Written representation regarding DA8853/2020 Location 34 Galvin Street South

Written representation for DA 0853/2020 proposed for 34 Galvin Street South Launceston

Written Representation - 34 Galvin Street

Regarding Application ID DA0853-2020 Property Address 34 Galvin Street South Launceston

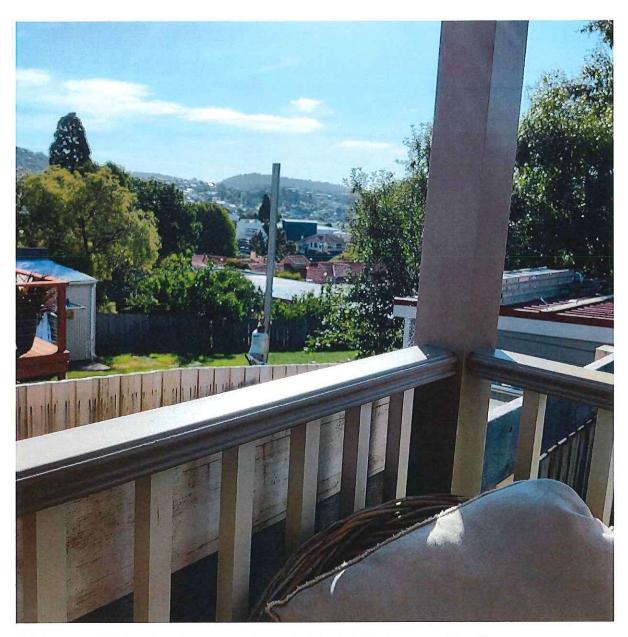
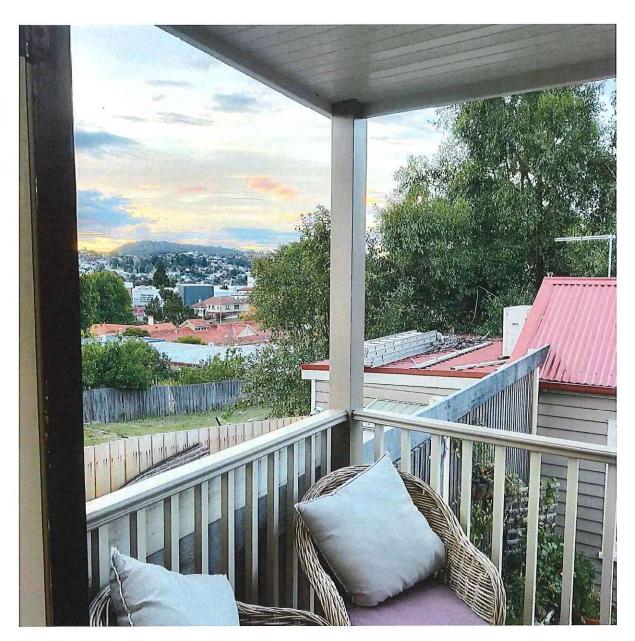
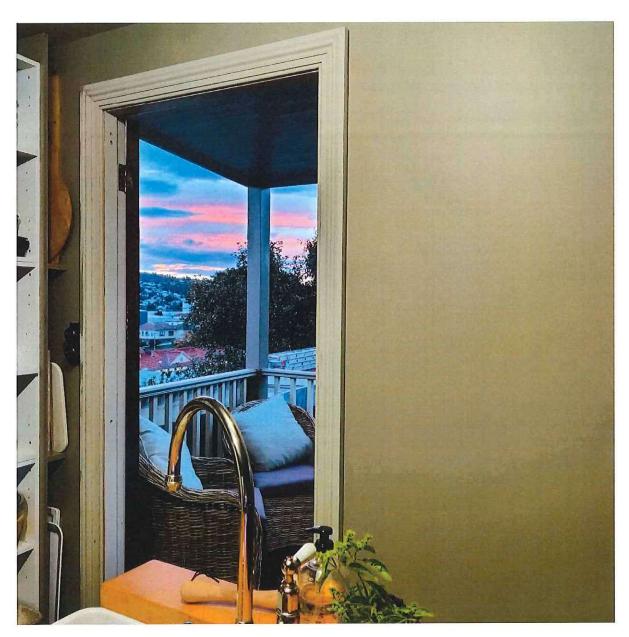
We have attached a few photos below to try and illustrate how this proposed dwelling will affect our amenity and privacy. We truly believe a dwelling of this height and bulk will also seriously affect the amenity of many surrounding properties.

This is only a 6 Metre plank to show the impact of the height of proposed dwelling

View from Kitchen Door and Outdoor Dining

View from Kitchen Door and Outdoor Dining

View from Kitchen
